**SECTION 00 9111**  
**ADDENDUM NUMBER 1**

DATE: May 19, 2022

PROJECT: Johnson County Conservation – Kent Park Campground Shower House

PROJECT NUMBER: 4217340

**Z1.01 – ELECTRICAL POWER PLANS**

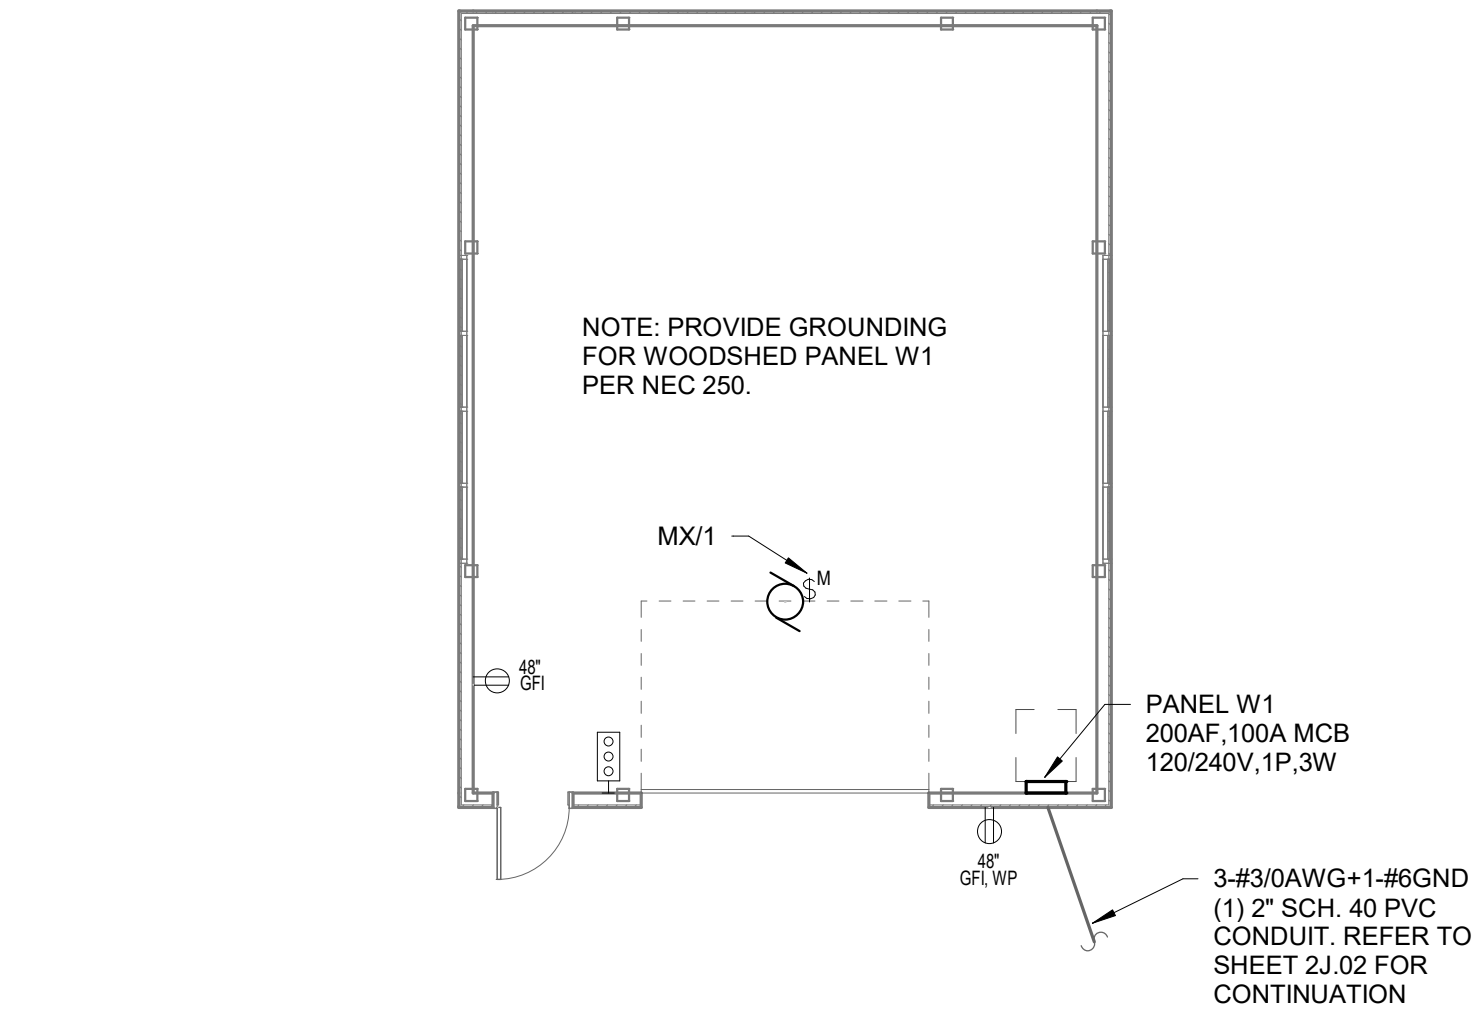
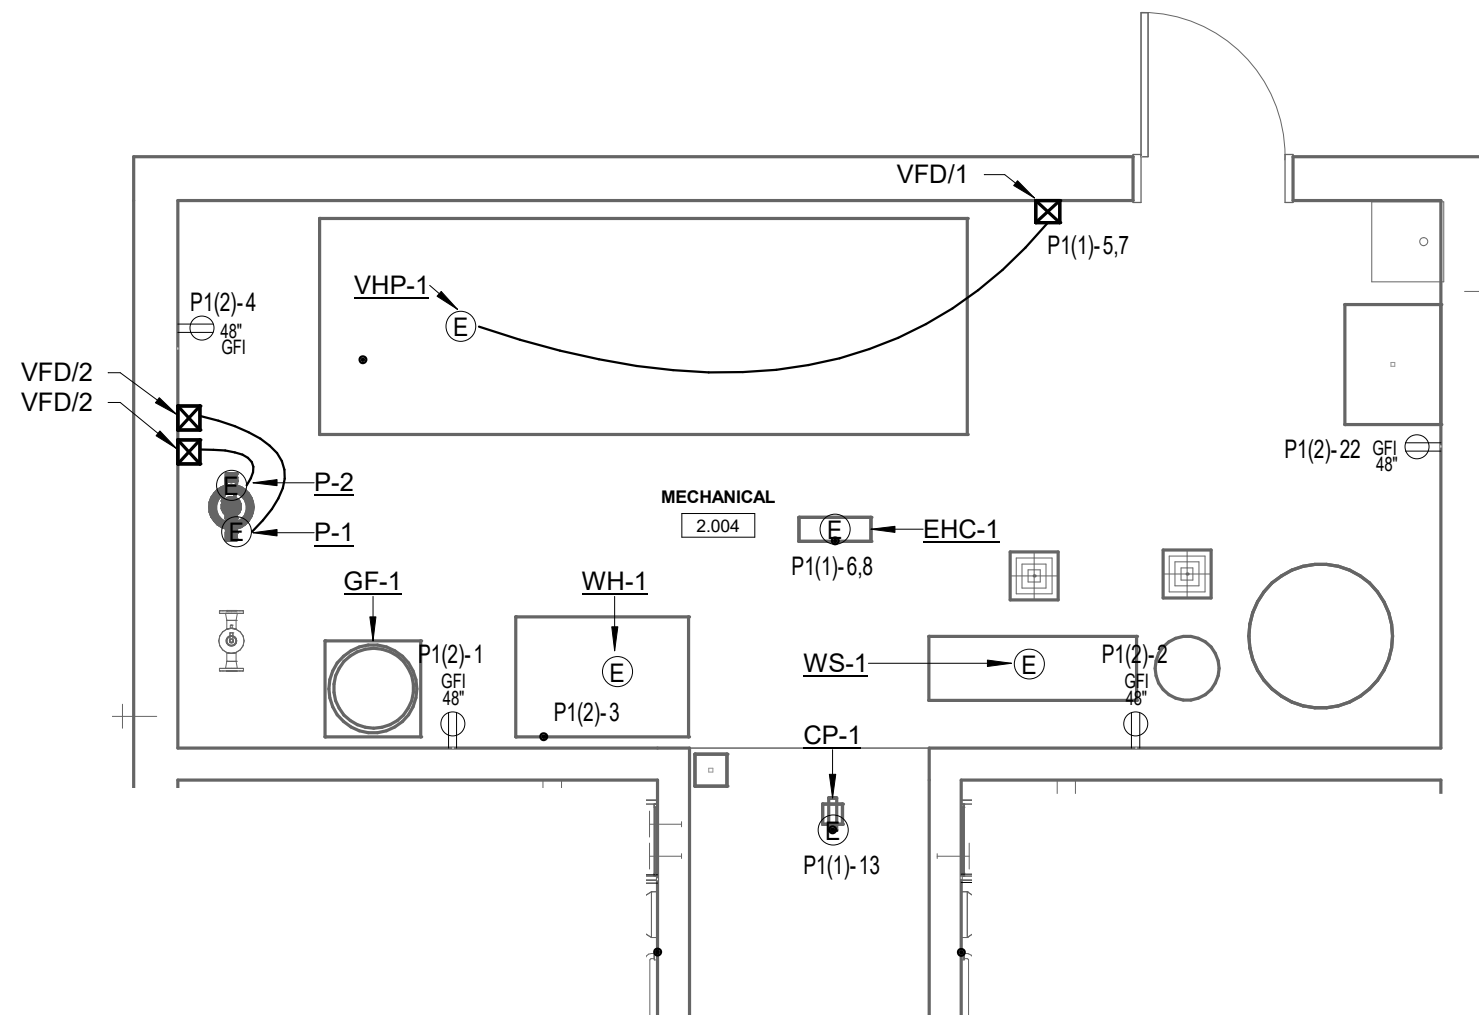
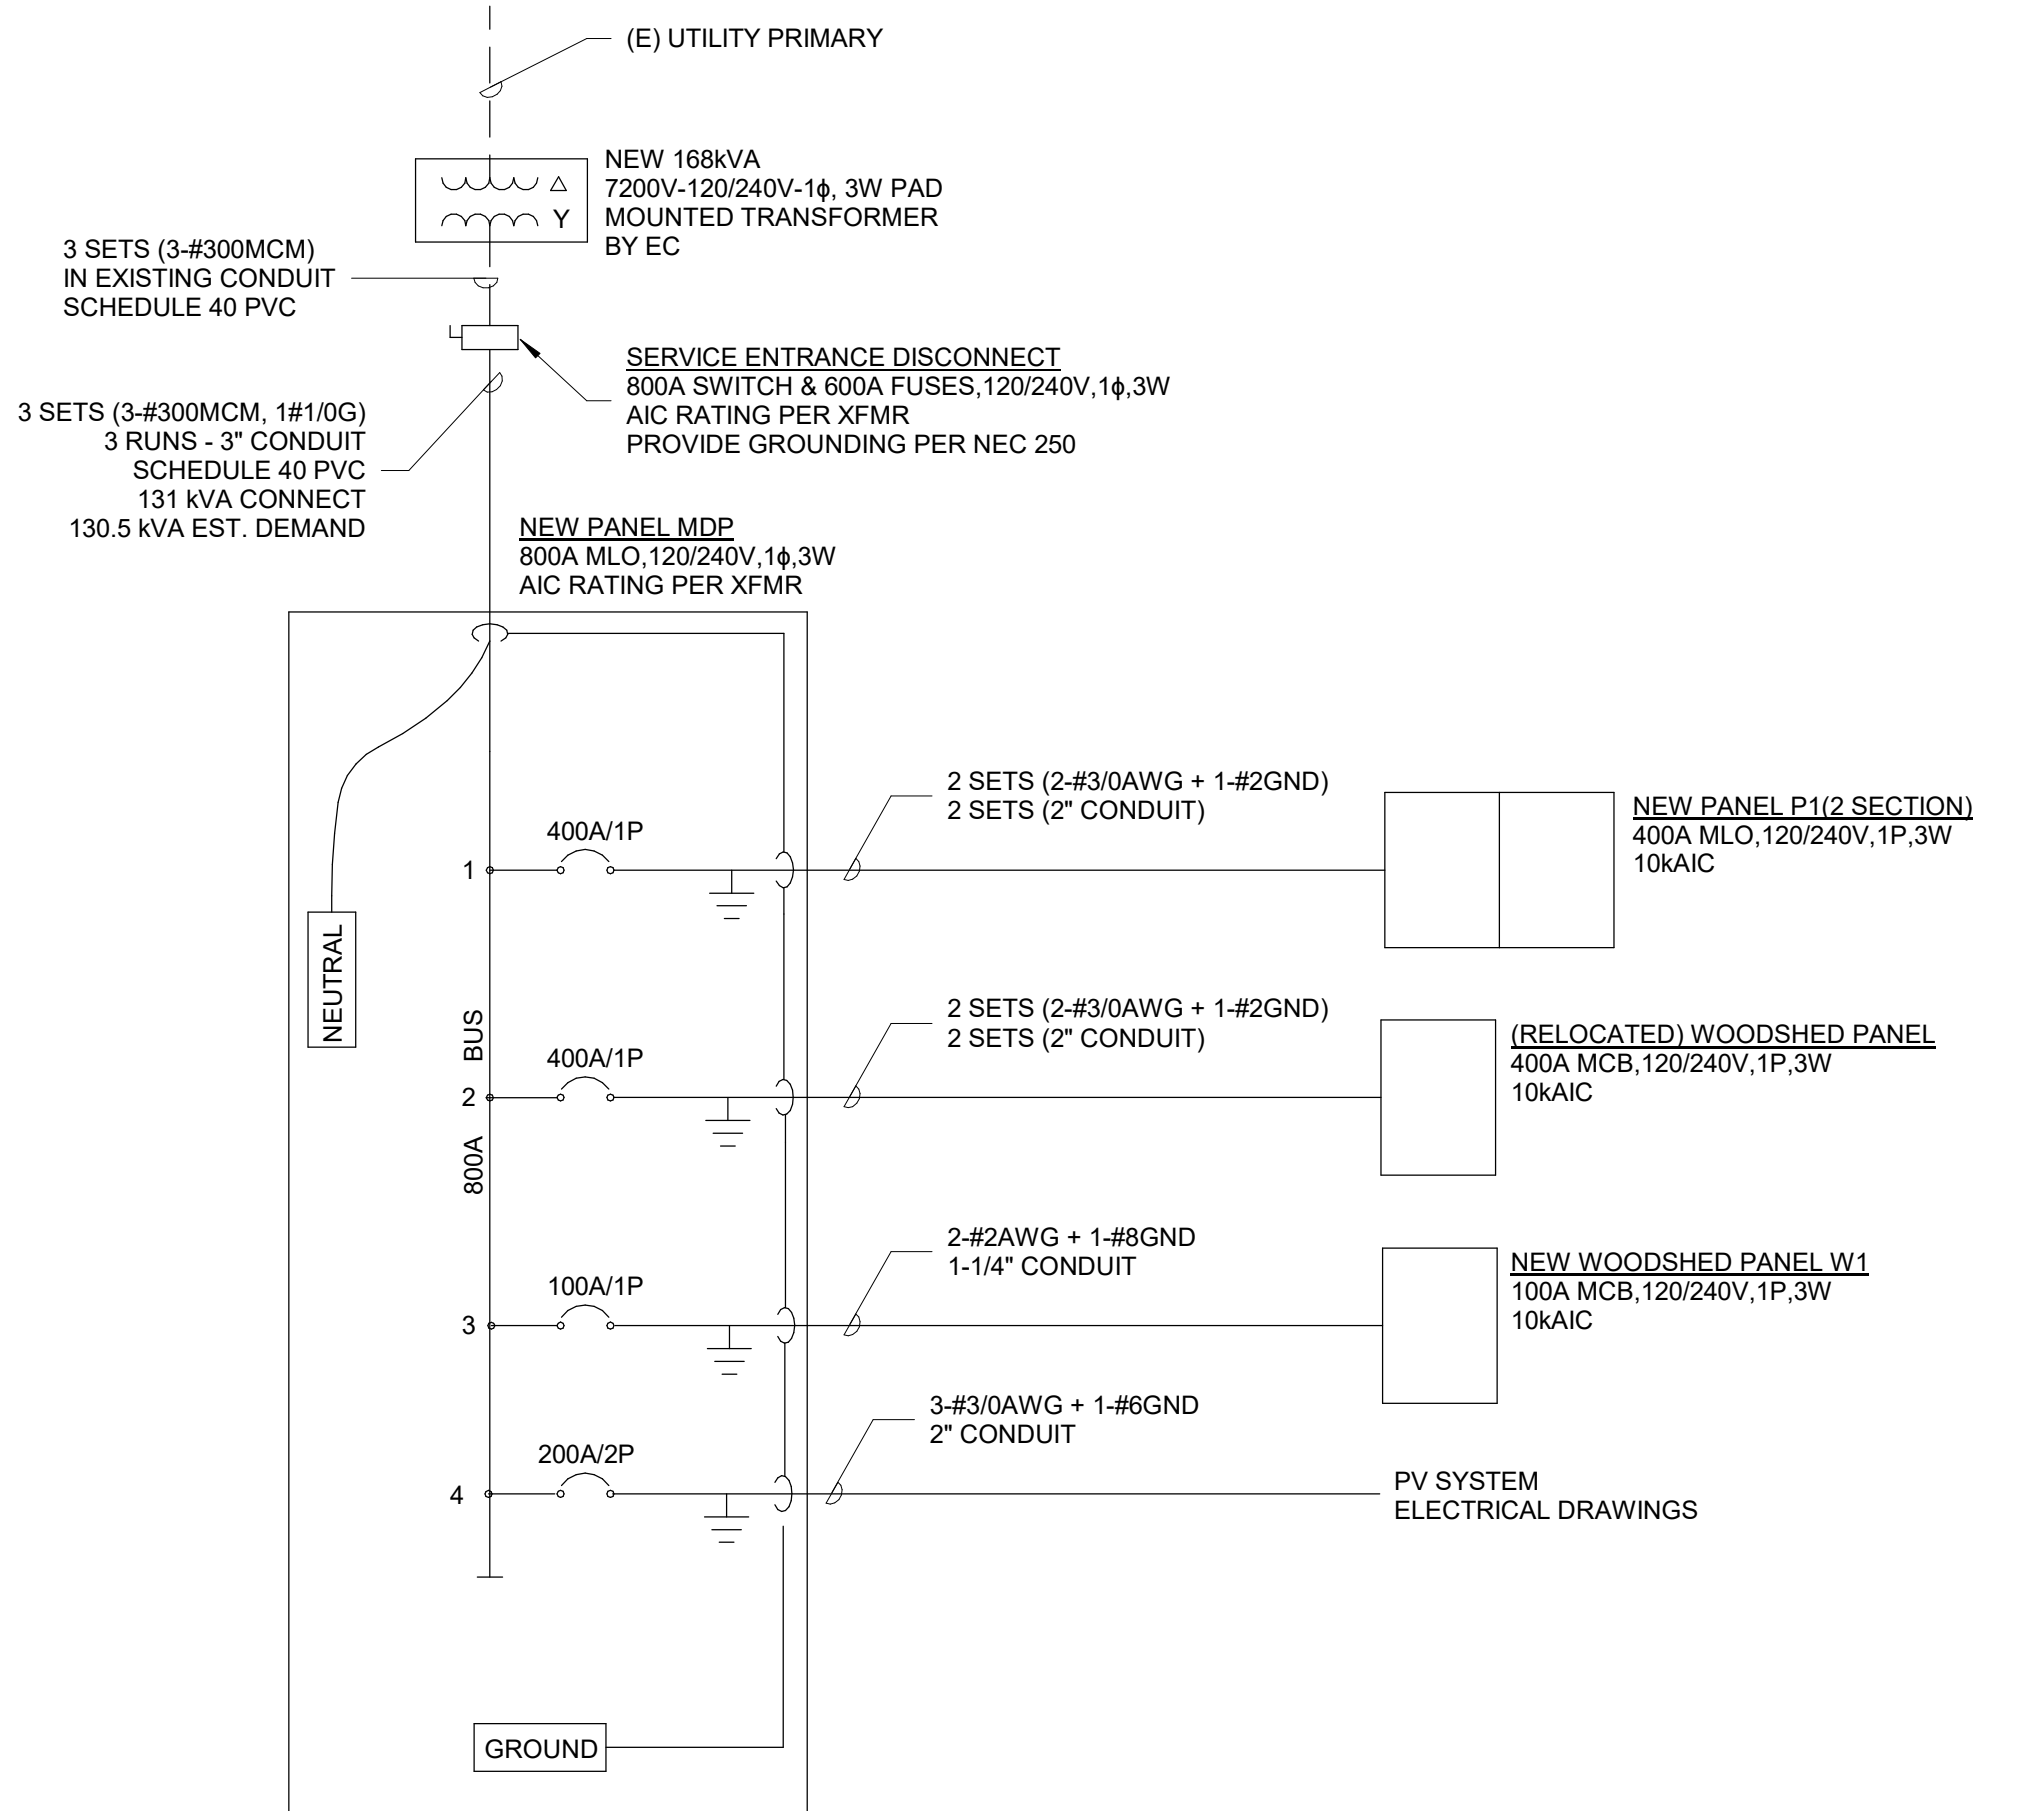
16. **REPLACE** sheet in its entirety.
